Form 3160-5  
(June 2019)UNITED STATES  
DEPARTMENT OF THE INTERIOR  
BUREAU OF LAND MANAGEMENTFORM APPROVED  
OMB No. 1004-0137  
Expires: October 31, 2021**SUNDRY NOTICES AND REPORTS ON WELLS**  
**Do not use this form for proposals to drill or to re-enter an abandoned well. Use Form 3160-3 (APD) for such proposals.**5. Lease Serial No. **MULTIPLE**6. If Indian, Allottee or Tribe Name  
**MULTIPLE****SUBMIT IN TRIPLICATE - Other instructions on page 2**

EOG Resources Inc. (EOG) respectfully requests the execution of the variance for Wellhead break testing and offline cementing for the following wells, as outlined below (and with the additional Offline Cement Intermediate Operational Procedure):

### Almost Eddy 30 Fed Com 500Hs

#### Revised Permit Information 03/23/2022:

Figure 1: Cameron TA Plug and Offline Adapter Schematic

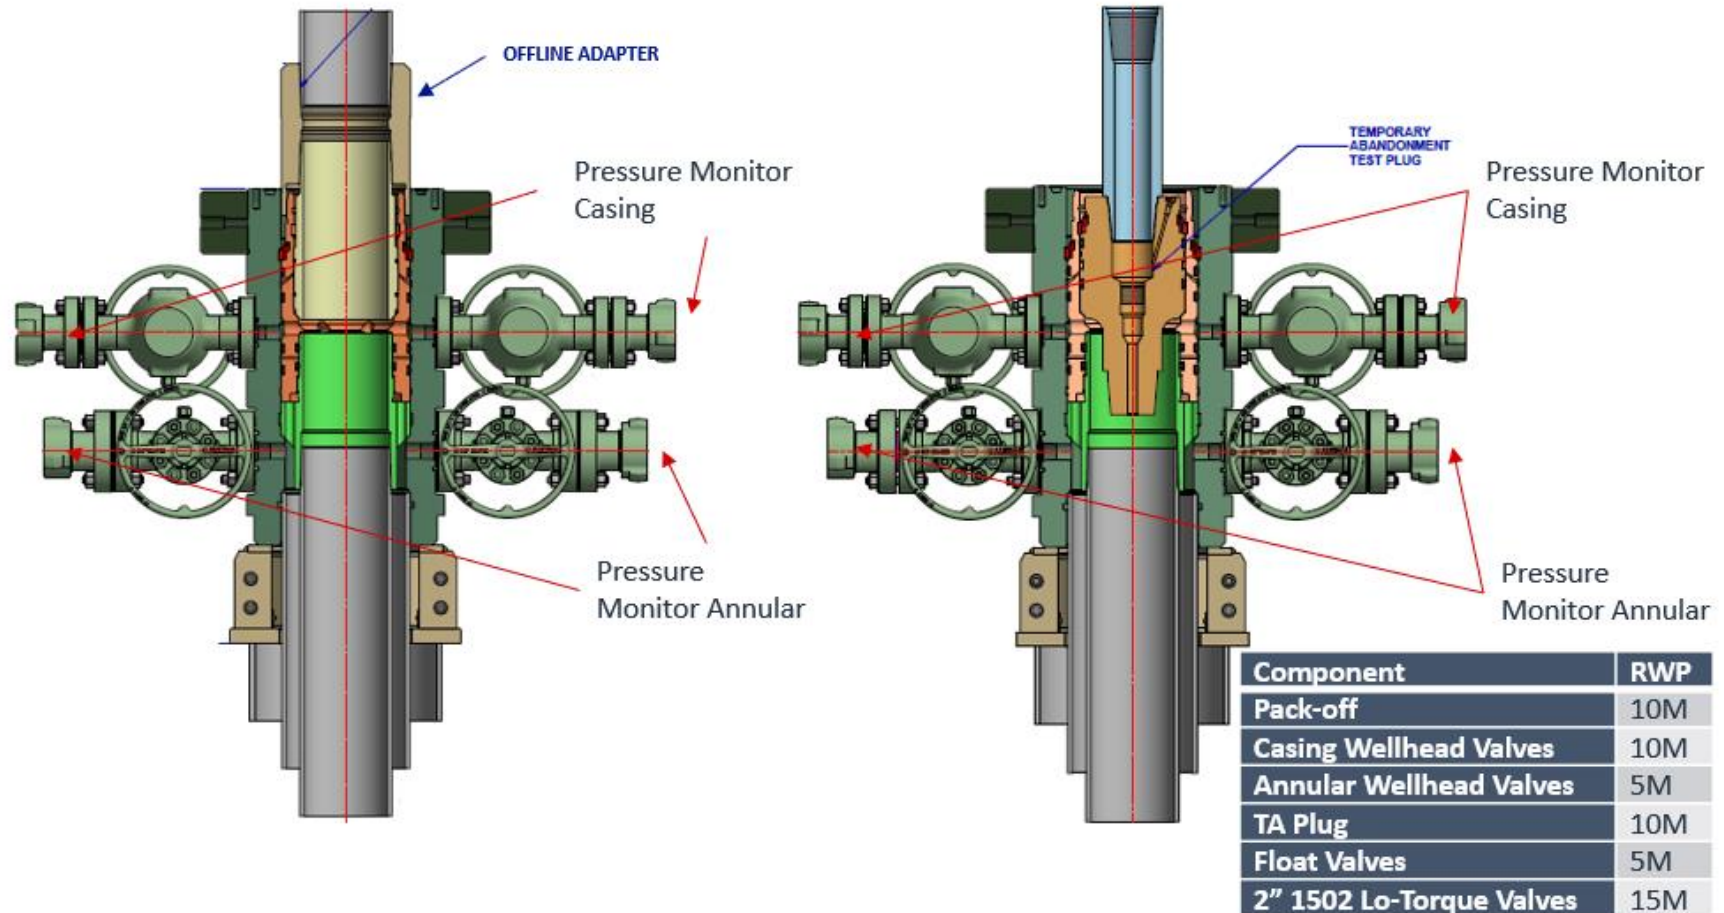
- c. Return line schematics can be seen in Figure 3.
10. Remove TA Plug from the casing.
11. Install offline cement tool.
  - a. Current offline cement tool schematics can be seen in Figure 1 (Cameron) and Figure 2 (Cactus).

Figure 3: Back Yard Rig Up

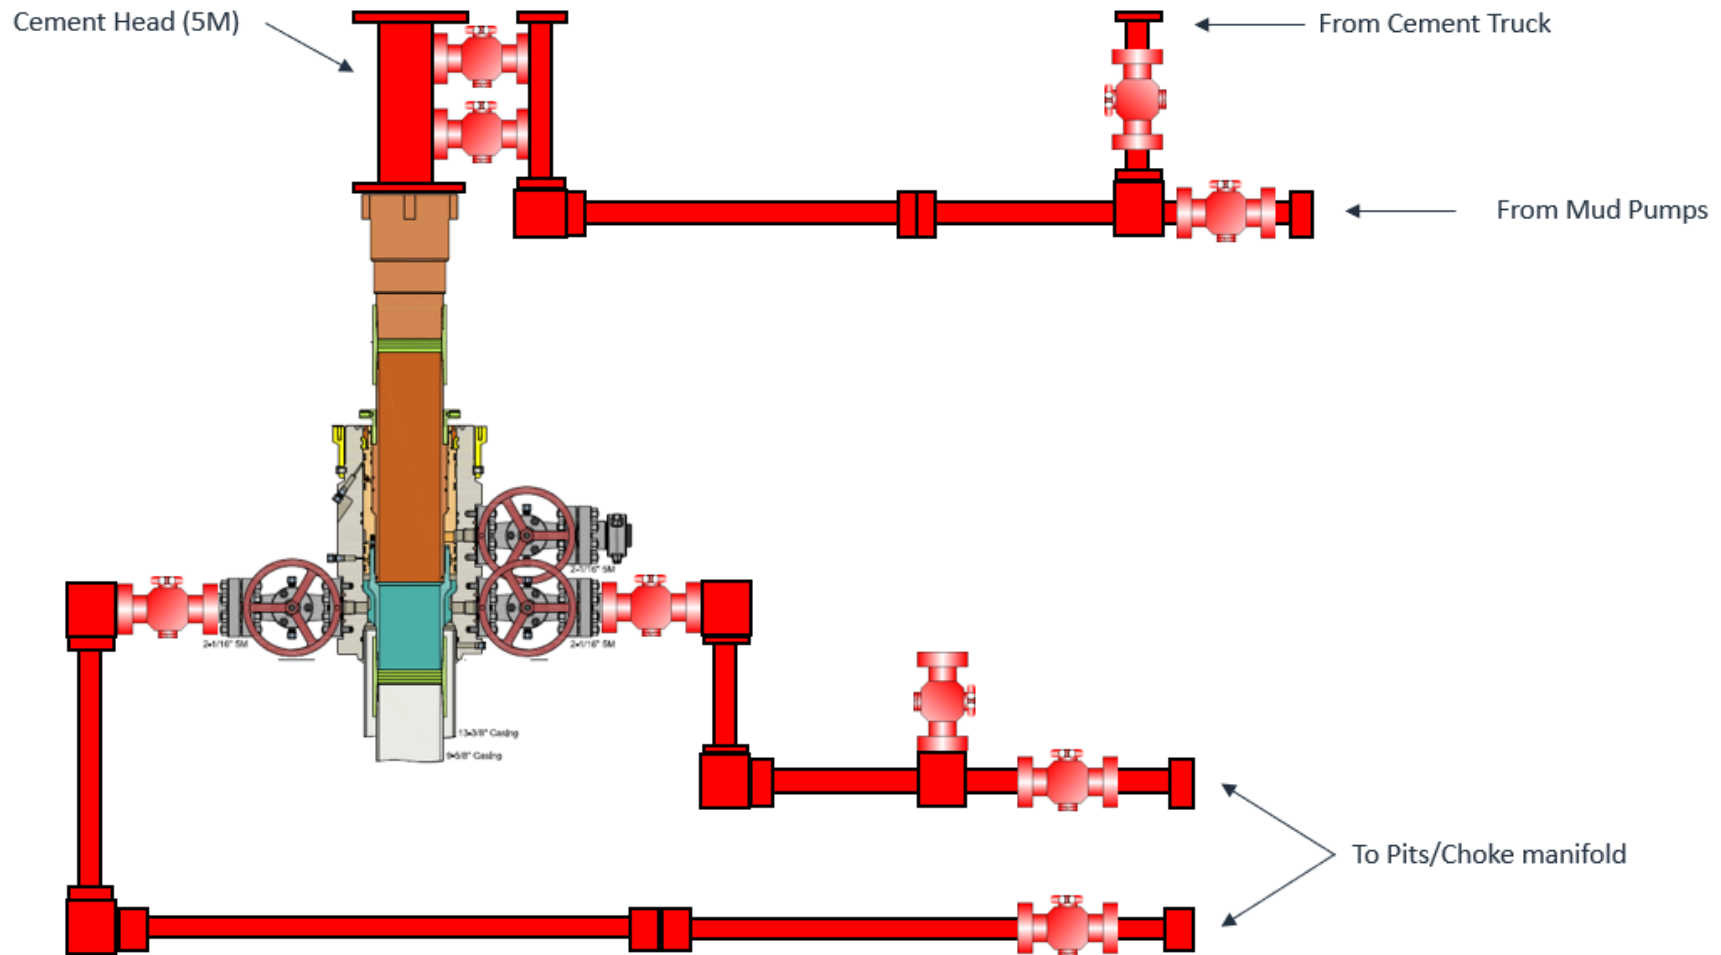
- a. Test all connections and lines from wellhead to choke manifold to 5,000 psi high for 10 min.
  - b. If either test fails, perform corrections and retest before proceeding.

Figure 4: Rig Placement Diagram

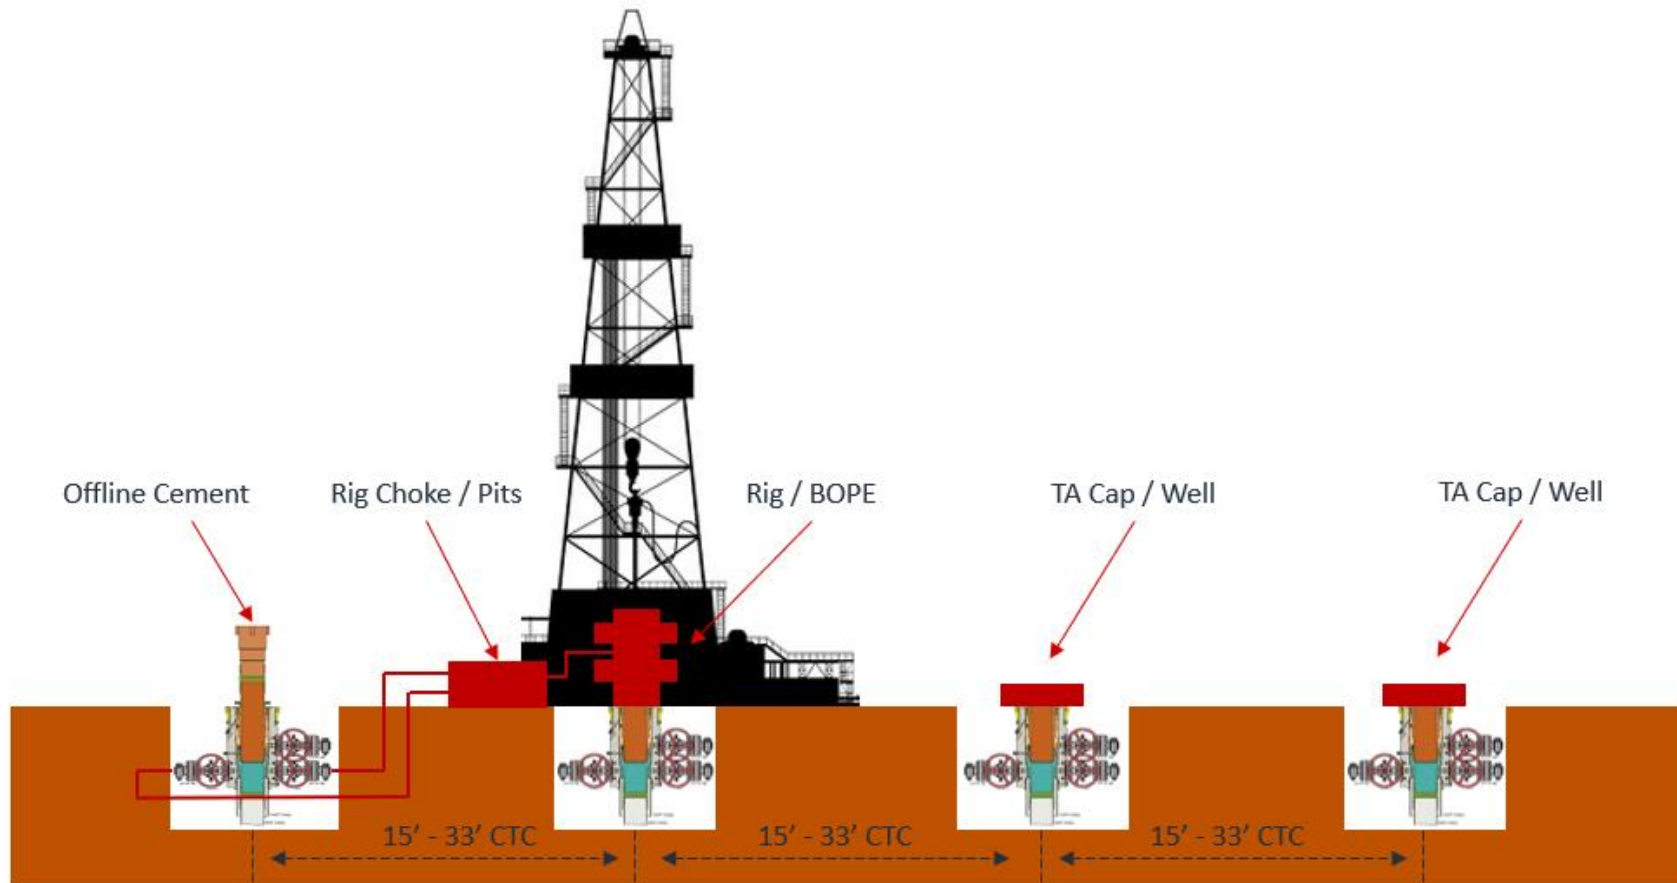
- e. Diagram for rig positioning relative to offline cementing can be seen in Figure 4.
9. Rig up return lines to take returns from wellhead to pits and rig choke.
